Joint Regional Planning Panel

Meeting Date: 18 June 2014

JRPP Number:	2013SYE094
DA Number:	13(208)
Local Government Area:	City of Botany Bay
Proposed Development:	<p>Integrated Stage 1 Masterplan Application seeking Joint Regional Planning Panel (JRPP) approval for redevelopment of the site for residential purposes; comprising:</p> <p>Five (5) buildings containing a maximum Gross Floor Area (GFA) of 45,662 sqm and Floor Space Ratio (FSR) of 1.469:1; building heights between two (2) storeys to eight (8) storeys; basement and ground level parking; 4,500sqm of publicly accessible open space; pedestrian and cycle through-site links; and new vehicular access from Pemberton Street. The proposal also includes site preparation works, remediation and dedication of land.</p>
Street Address:	52-54 Pemberton Street, Botany
Applicant:	Newtown Dyers and Bleachers Pty Ltd
Number of Submissions:	Nine (9), including two (2) form letters
Recommendation:	Refusal
Report by:	Rodger Dowsett, Director Planning and Development, City of Botany Bay

Figure 10: existing buildings compared to proposed building footprints and heights.

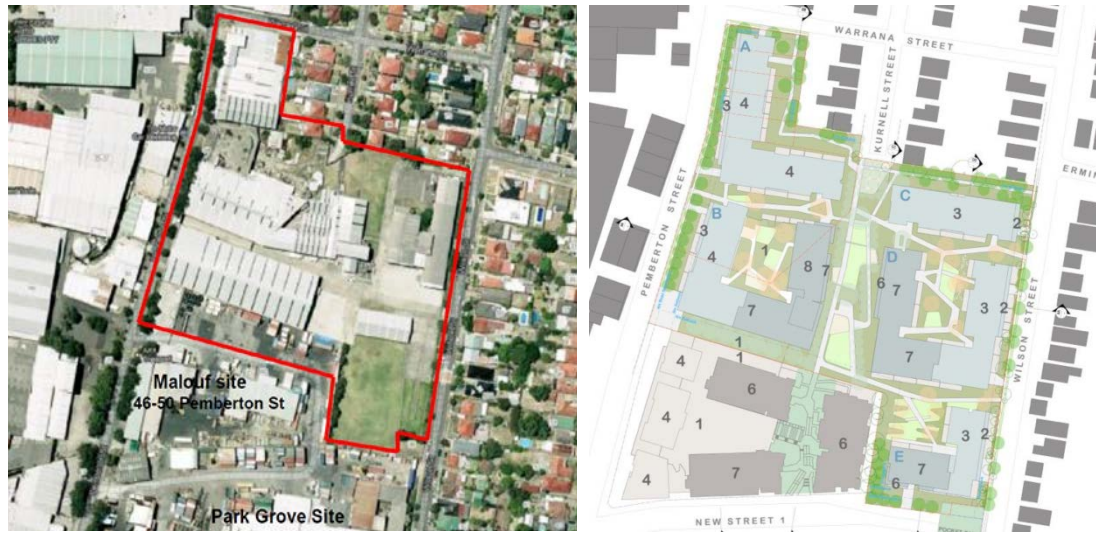
Figure 11 shows that the existing built form is concentrated to the west of the site and is adjacent to industrial development located in Pemberton Street. With the exception of dwellings located on the western side of Kurnell Street, existing buildings are generally sympathetic to nearby residential dwellings in terms of height, scale, siting and separation distances.

The Master Plan introduces flat buildings along Wilson Street (2-3 storeys) and New Street 1 (seven (7) storeys). Larger buildings will also interface with single dwellings in Kurnell Street (4 storeys).

A multi-dwelling building type, such as townhouses would also provide a more appropriate interface with adjoining dwellings to the north and adjacent dwellings to the east. Setbacks at the upper three (3) storey level would also improve the built form. Other aspects of the design which could lead to an improved development interface could be considered and addressed at Stage 2. The same applies to the four (4) storey eastern and northern wing of Building A which adjoins single dwellings in Kurnell Street. The northern wing of Building A and the proposed four (4) storey component would also be non-compliant with Council's height of building control of 10m.
